Docket Nos. 50-352
50-353

Subject: Limerick Generating Station (LGS)-Units 1&2
Open Items from NRC Draft Safety Evaluation
Report (DSER) - Structural Engineering
Branch (SEB)

ENCLOSURE 1
Response to LGS DSER-SEB Open Item Numbers 1, 4, 8, and 9

COMPARISON OF MODAL PROPERTIES
CONTAINMENT MODEL - VARIATION OF VERTICAL PLATFORM MASS

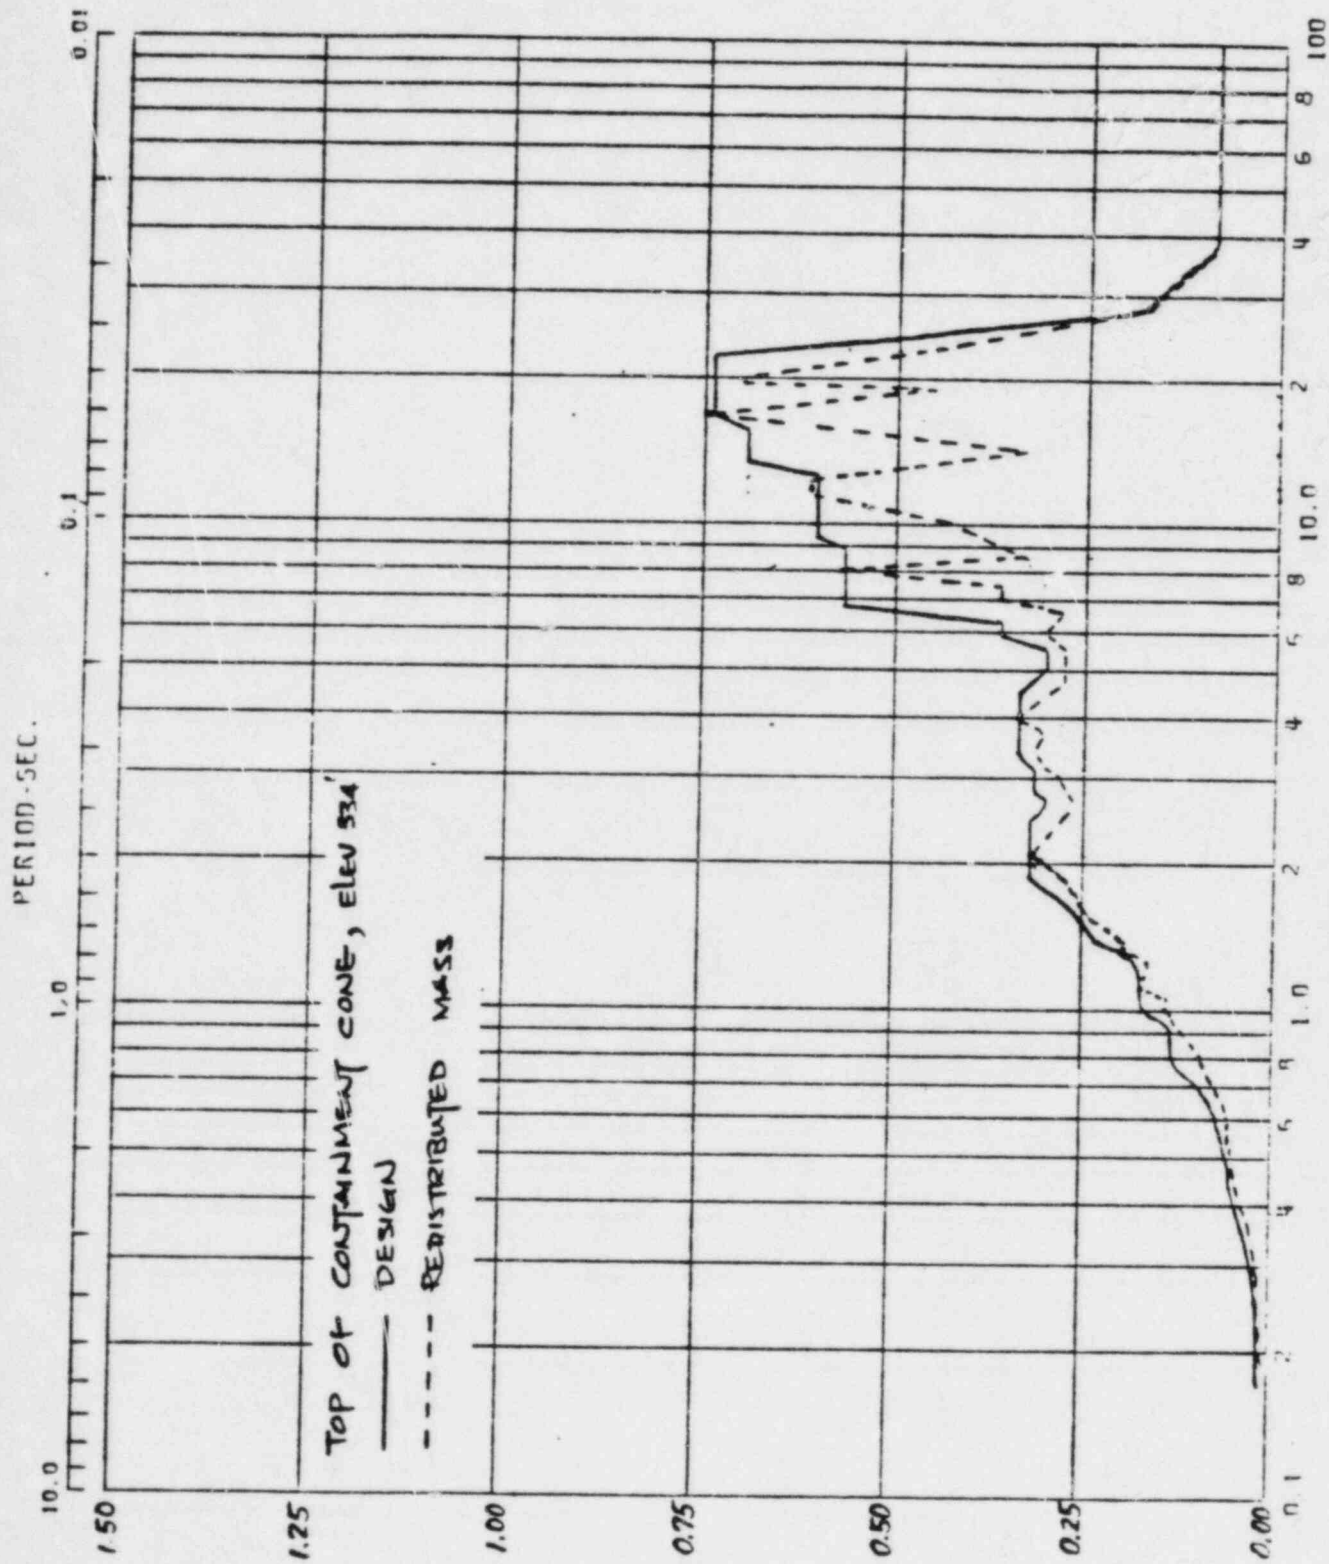
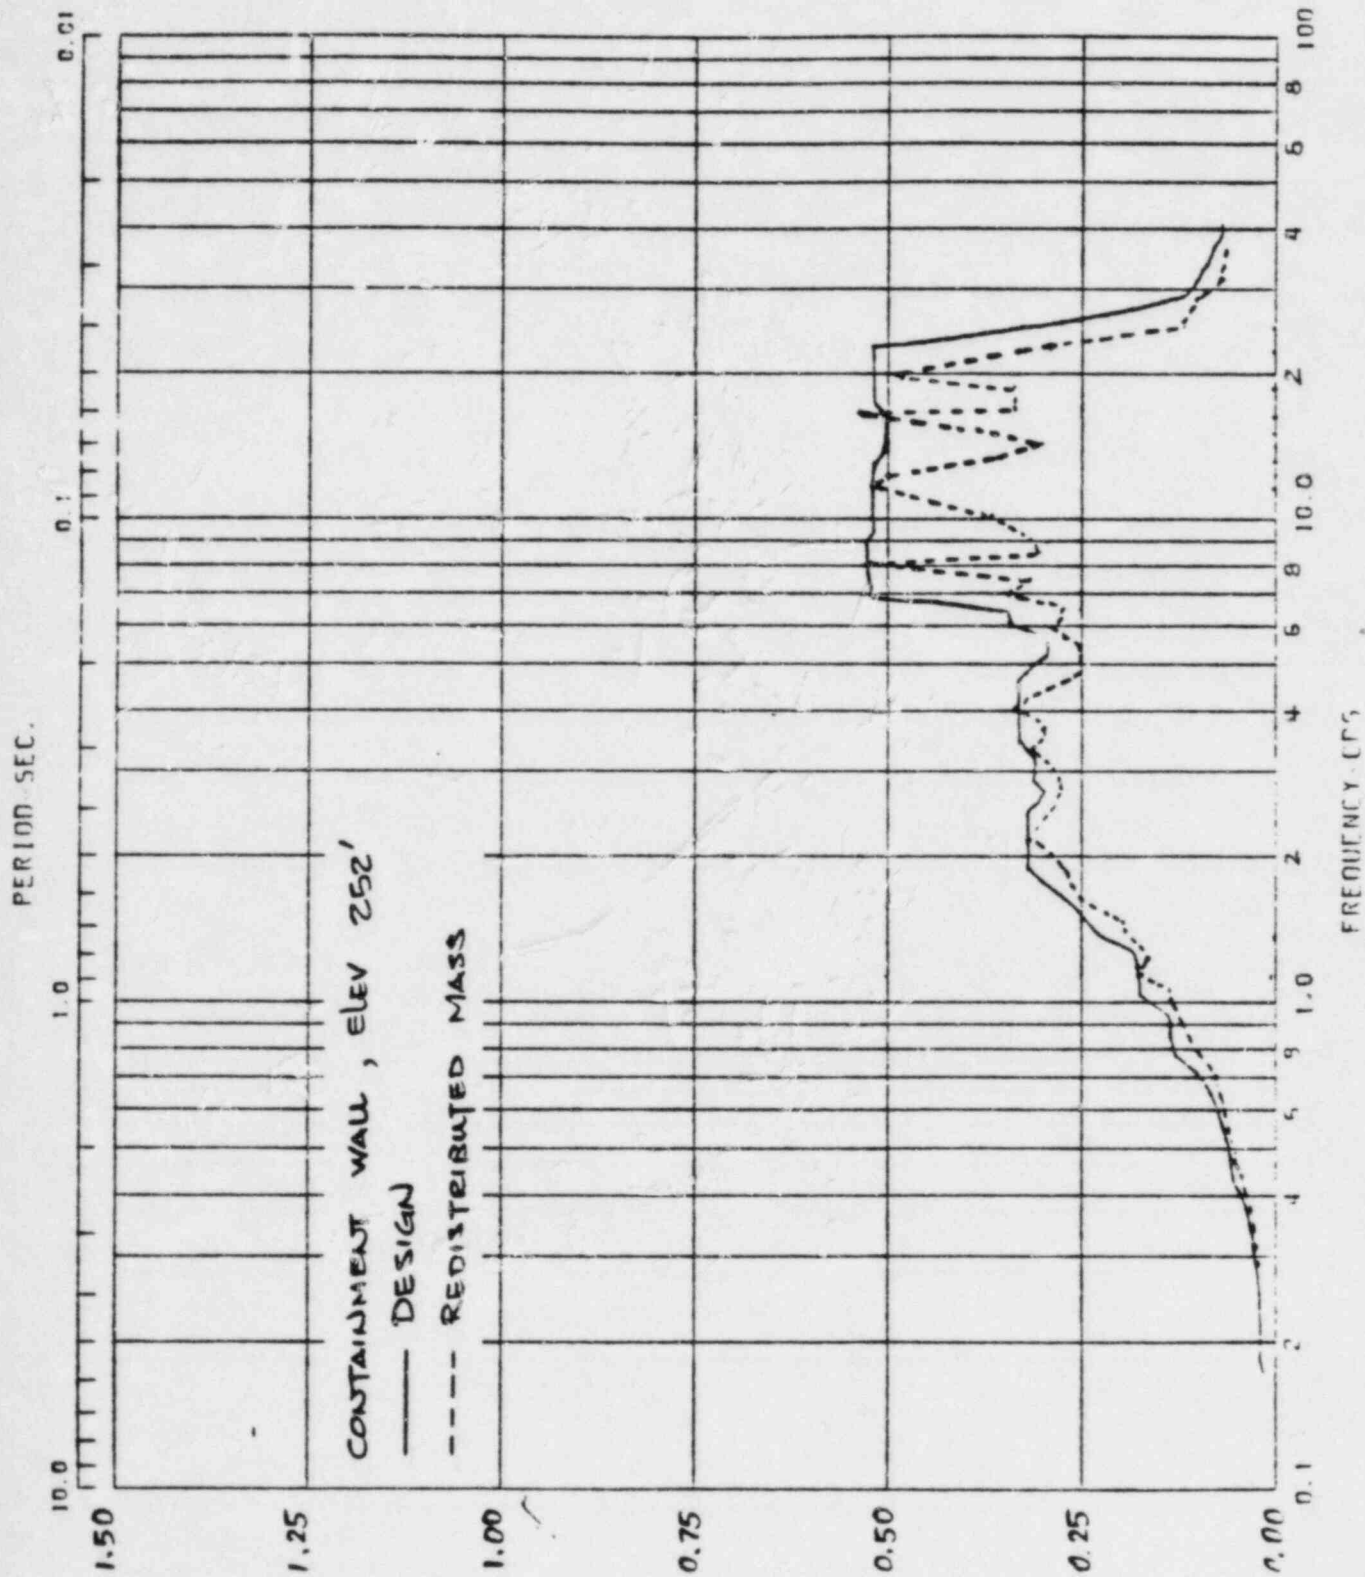
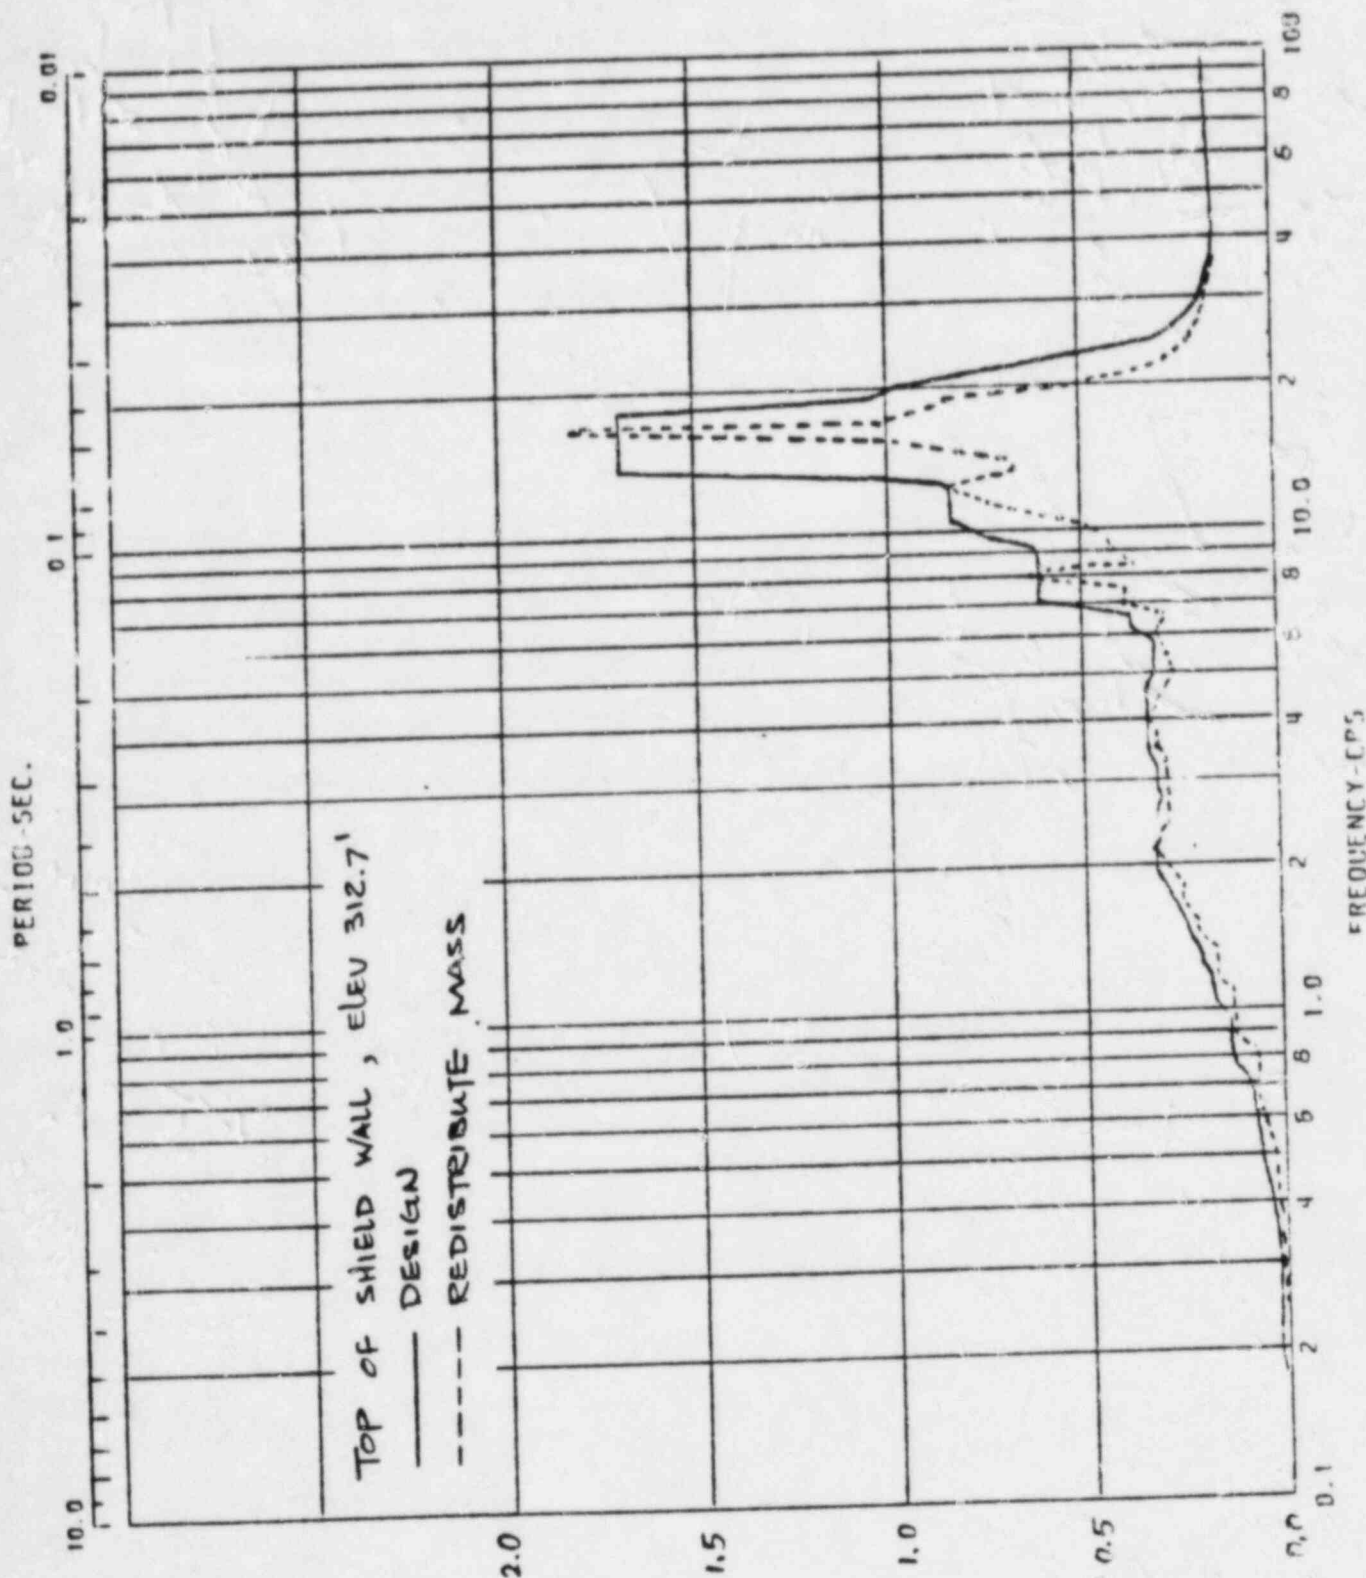
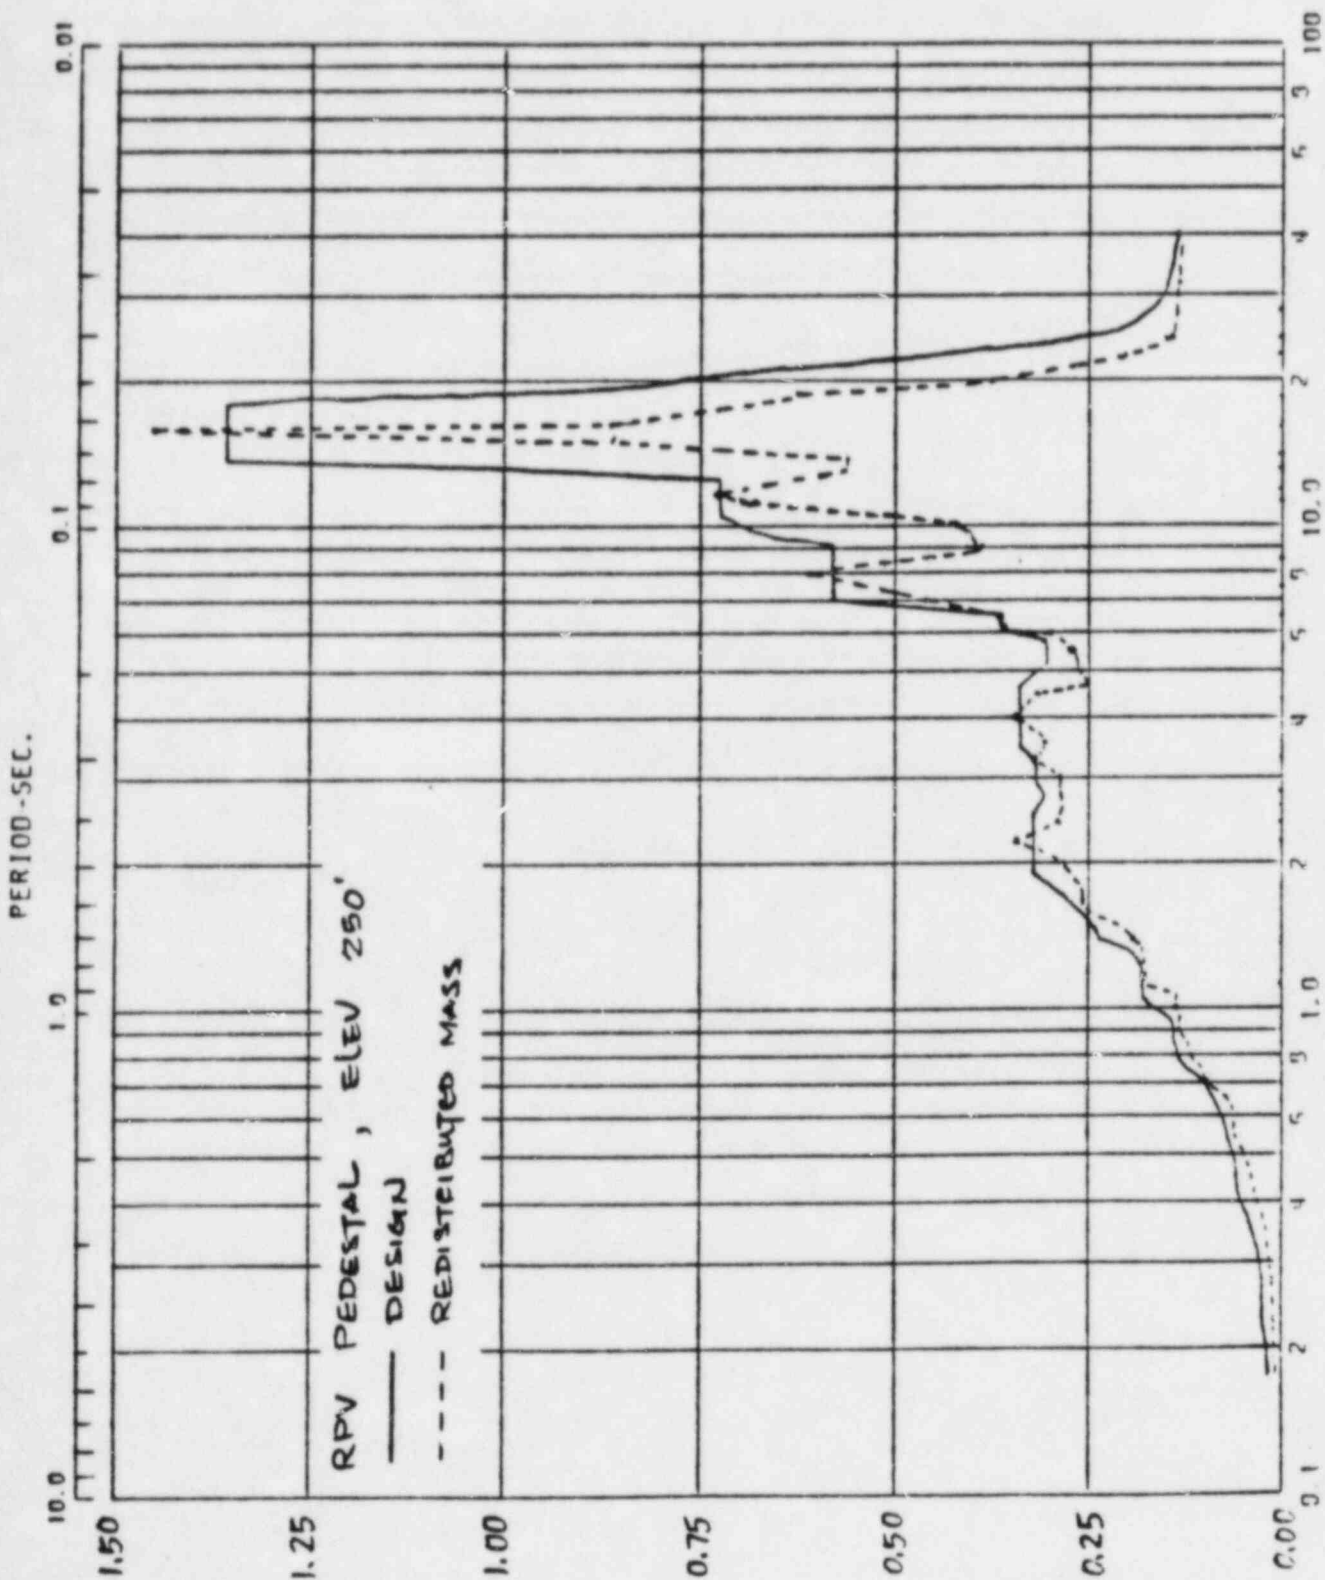
In addition to the problems with the rock parameters mentioned in (3) above, a structural design audit performed by the staff revealed problems with the containment dynamic model. These problems consist of errors in calculating the containment diaphragm slab spring stiffness and mass distribution of the containment building floors. The staff considers these problems to be open issues.

All platforms spanning between the containment wall and the RPV pedestal wall in the drywell are supported in the horizontal direction only at one end and are free to slide at the other end. They are supported at both ends in the vertical direction. Current horizontal and vertical seismic models of the containment structure assumed a platform mass distribution of 80% to the containment wall and 20% to the pedestal wall. A study has been performed using the uncracked containment models to determine the effects of different distribution of this platform mass.

The horizontal study model considers 100% of the platform masses lumped to the restrained ends and zero mass to the unrestrained ends. The vertical study model redistributes the platform masses to the containment wall stick and to the RPV pedestal stick of the model according to tributary area (approximately 60% to the containment wall and 40% to the pedestal wall).

The study models were analyzed for the OBE event and the results compared to the design values. These comparisons are shown in attachment 2 for the horizontal model and in attachment 3 for the vertical model.

These comparisons show that the distribution of platform masses have negligible effect on the structural response of the containment structure. Therefore, the current seismic analysis of the containment structure is adequate.

PLAN AT EL 217'-0"

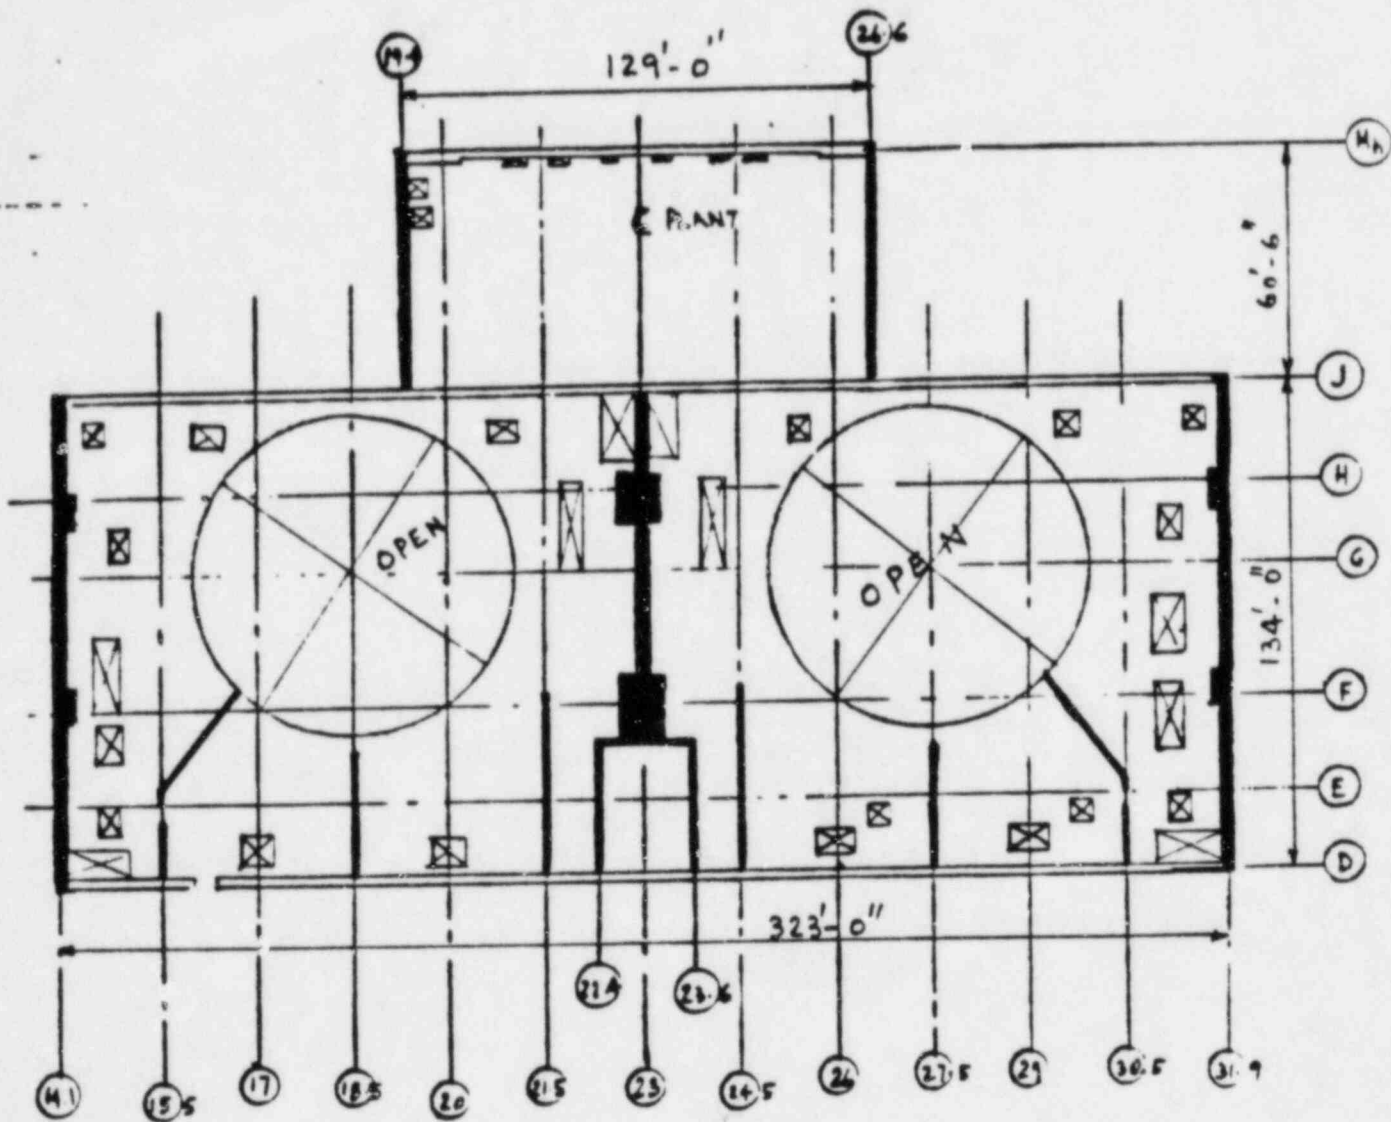
During a structural design audit of the reactor/control building calculations by the staff, it was learned that the horizontal load transfer assumptions between the roof/floor diaphragms, the shear walls and the foundation were not clear. To verify the logic of the load path assumptions relied upon, the applicant should provide a description of the assumptions made and verification of agreement between the calculations and the assumptions. The staff considers this to be a confirmatory item.

- 7) An illustrative example of the above assumptions and procedures is presented in the attachment. Walls on Col. line 19.4 and 26.6 between elev. 200/201' and 217' at the Reactor/Control Enclosures have been analyzed for the N-S earthquake.
